Project:
MN2A

Title:
NMA Bay Study 01
Entrance

3.0 Drawing Register

The drawing register below shows the consented drawings on the left with the proposed replacement drawing on the right.

Proposed
Basement Plan

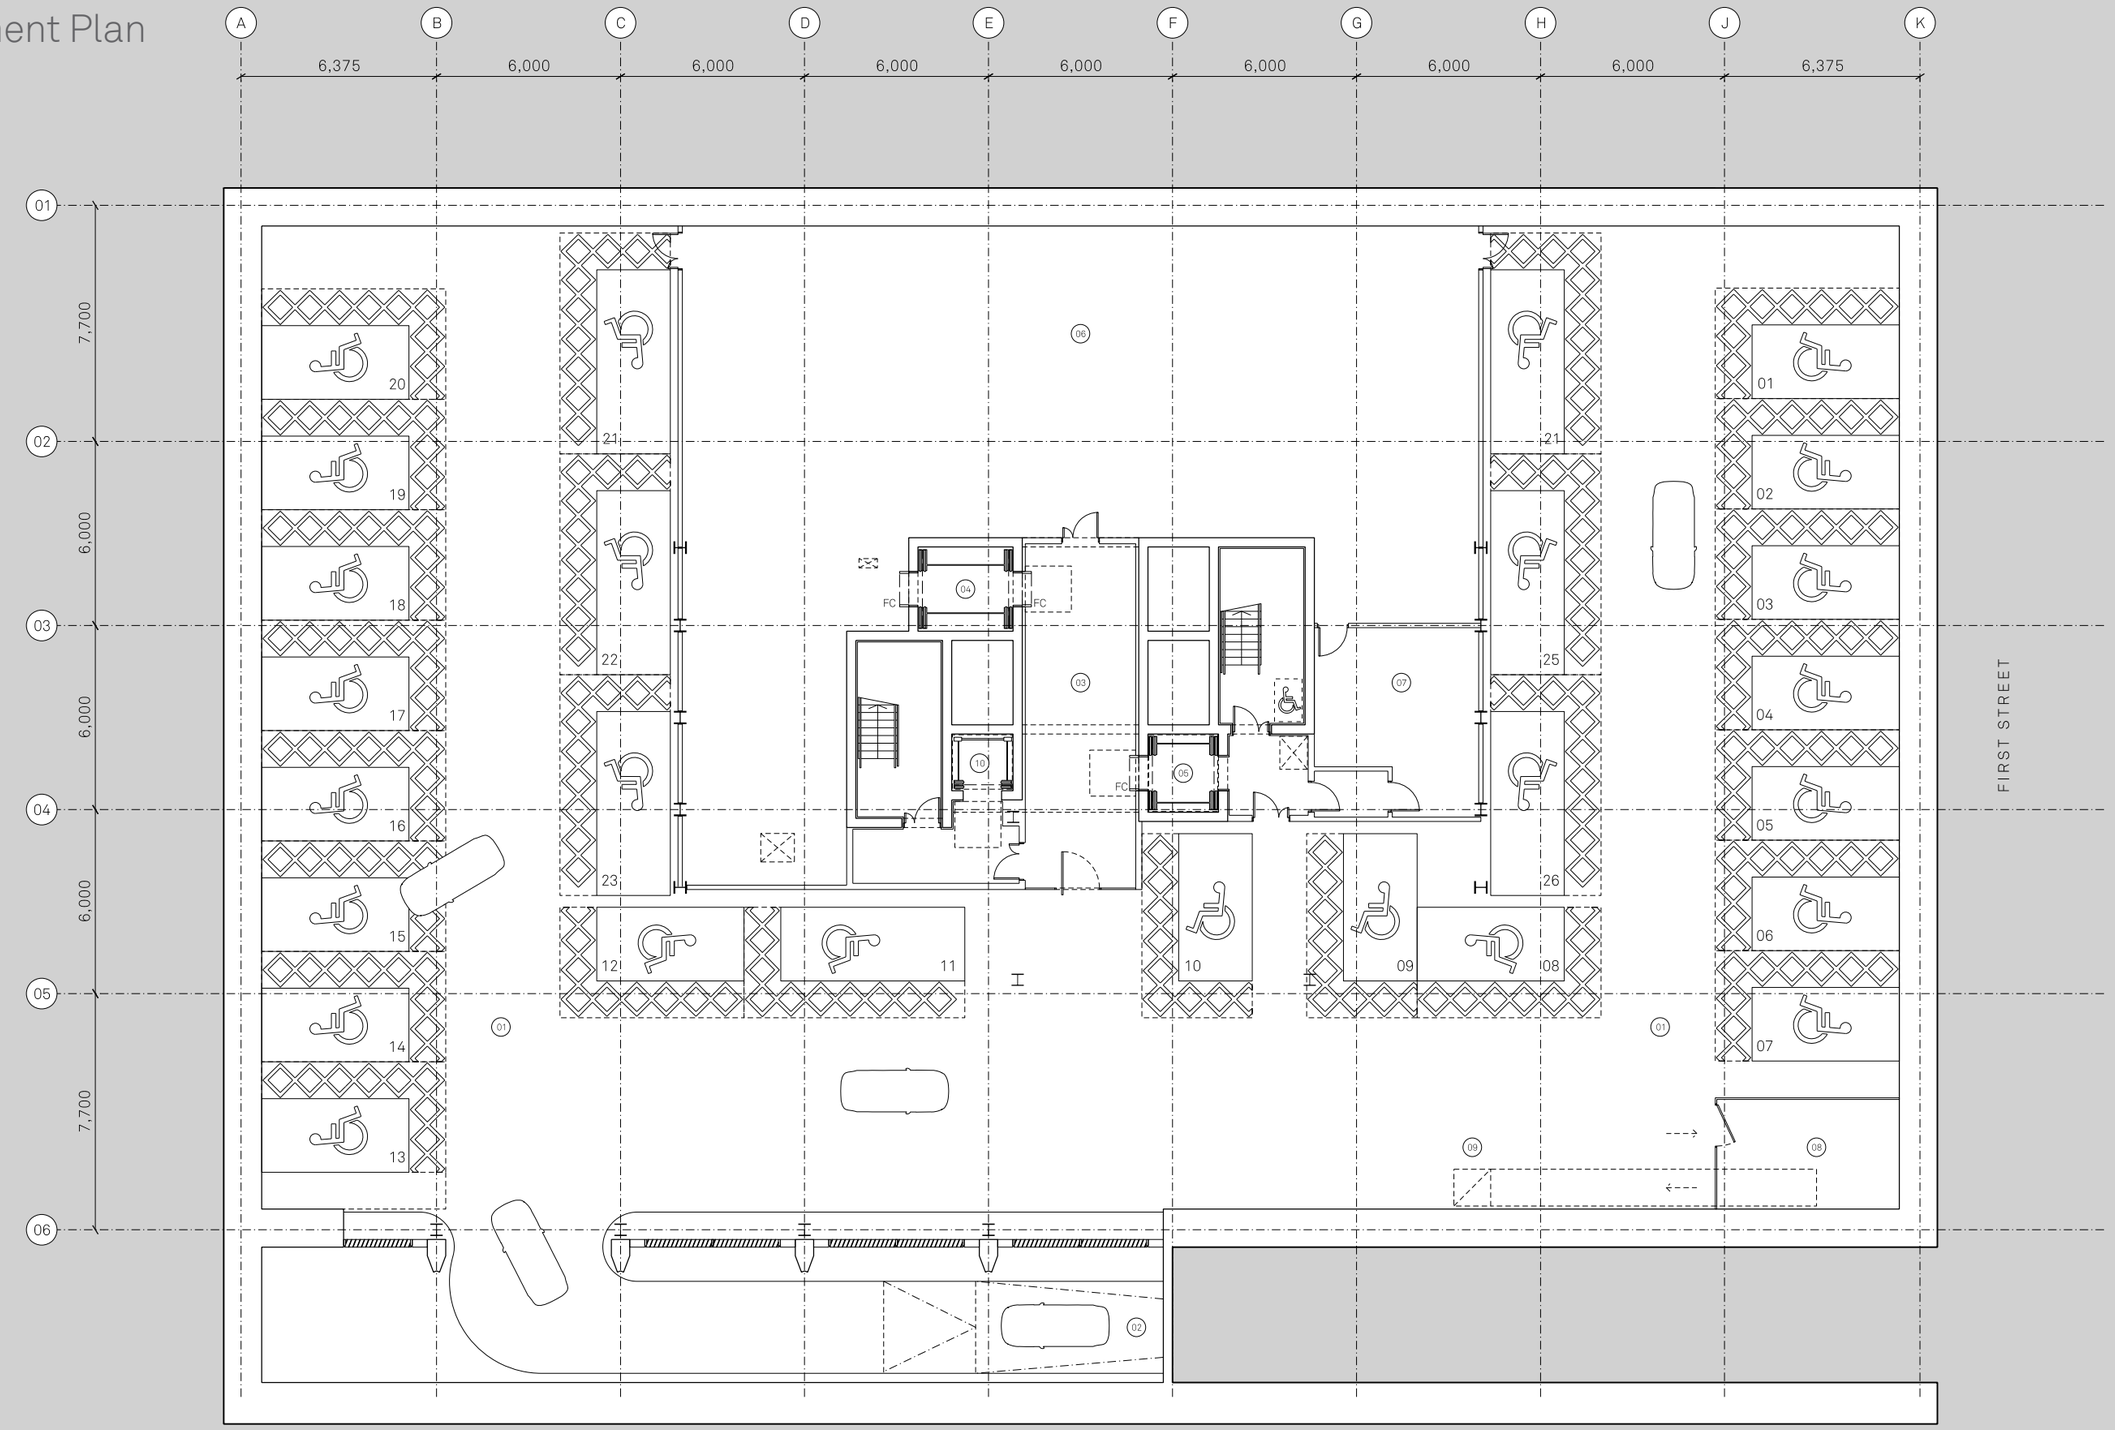
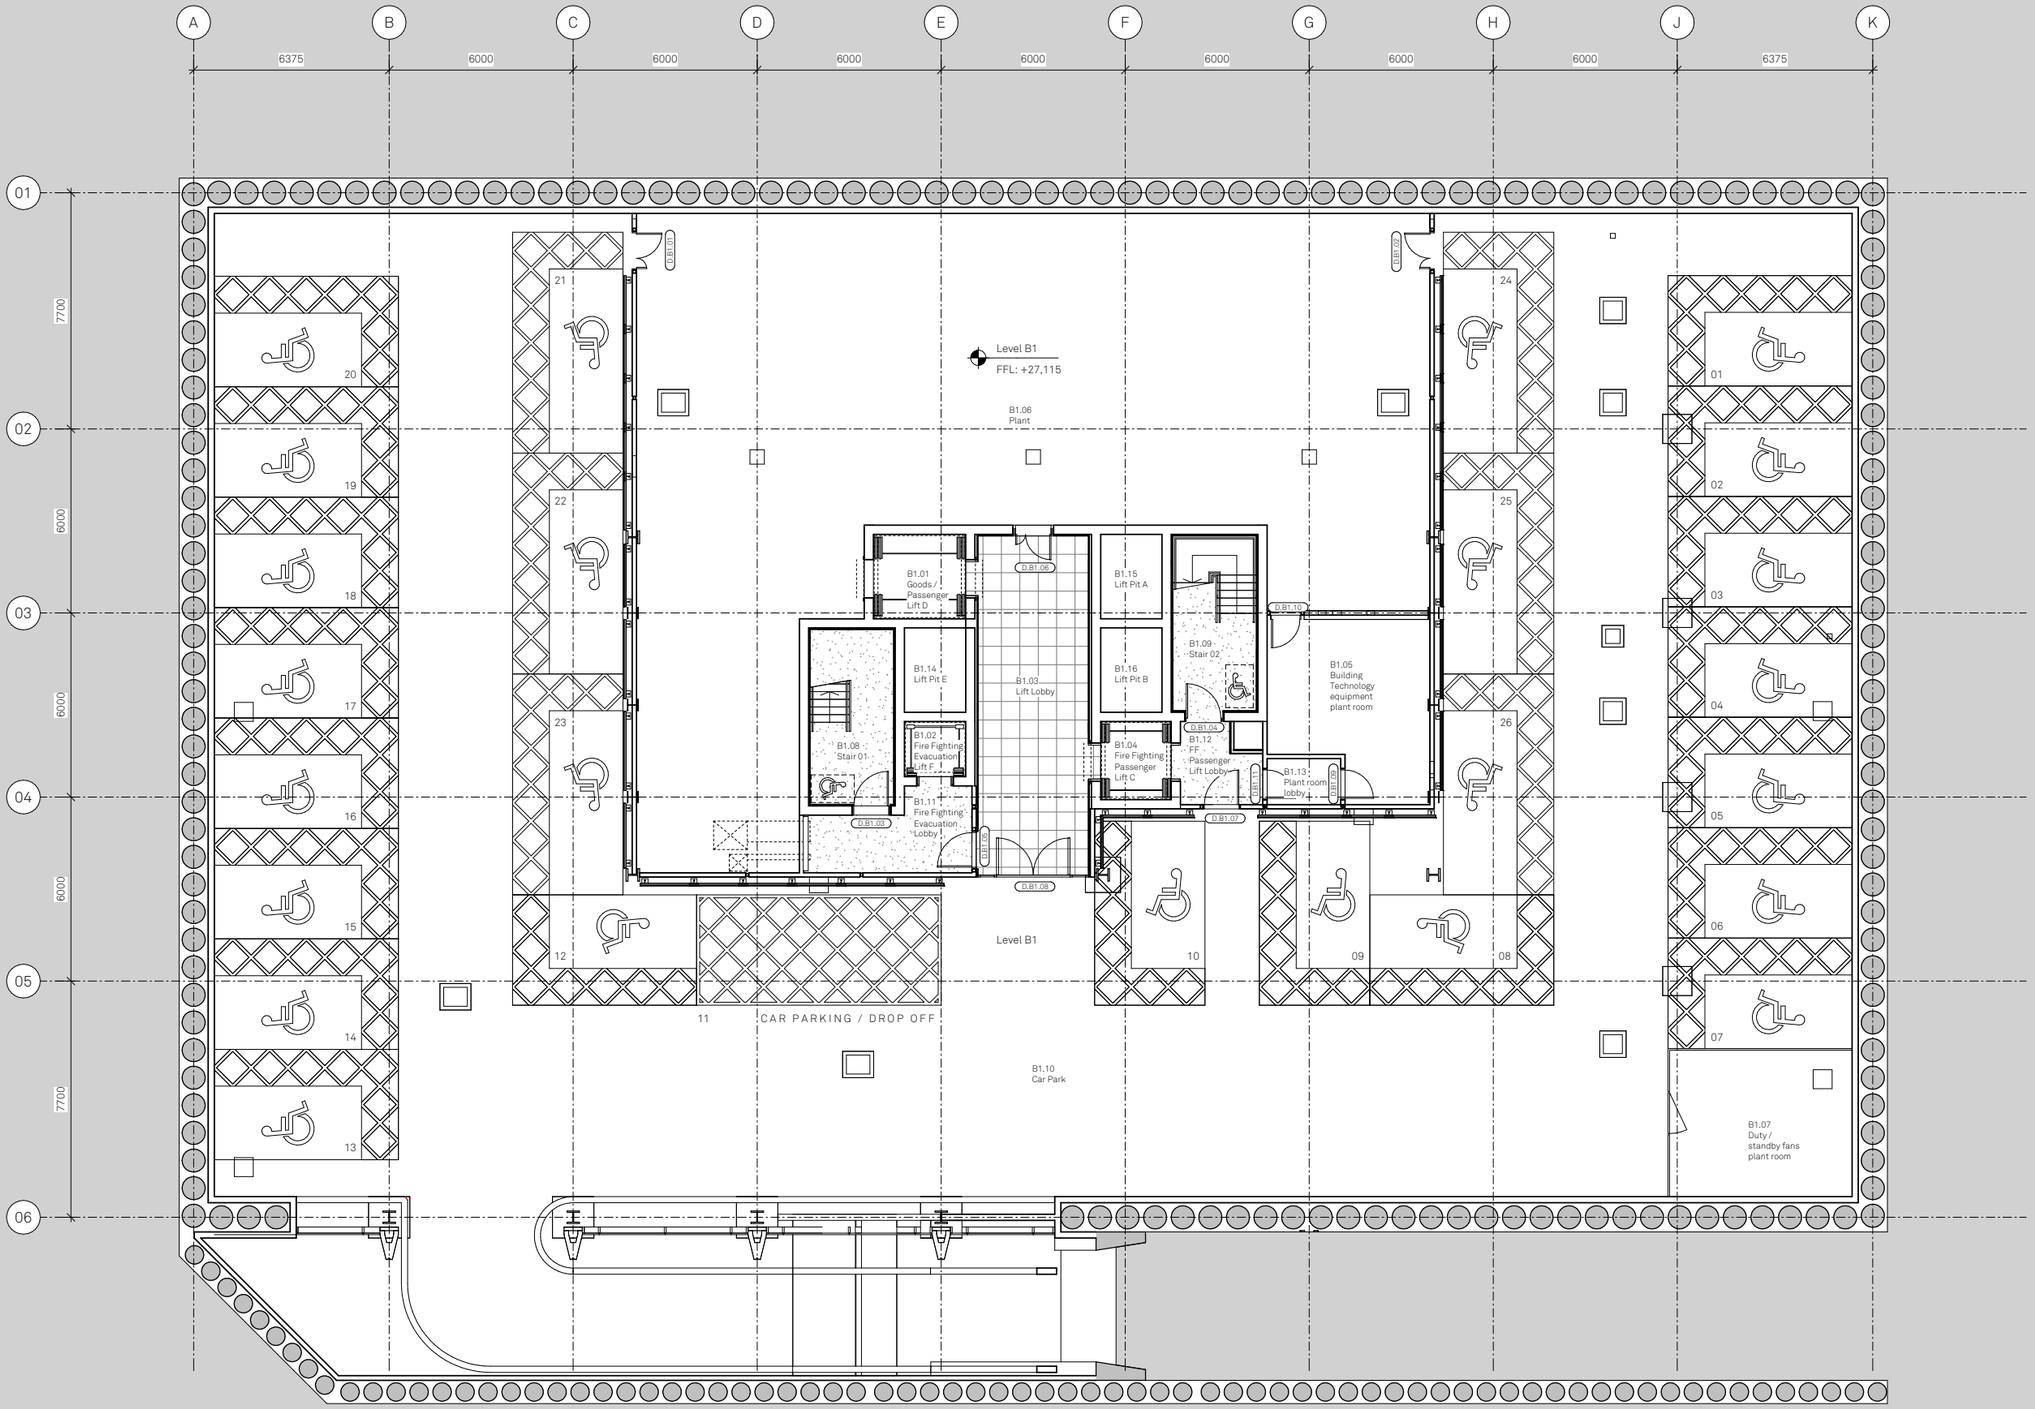
Rev:	Date:	Details:
P01	19/03/24	Issued for Planning
C02	18/03/24	Updated to TVR007, TVR011 and TVR013. Issued for Construction
C01	18/08/22	Issued for Construction - First Issue
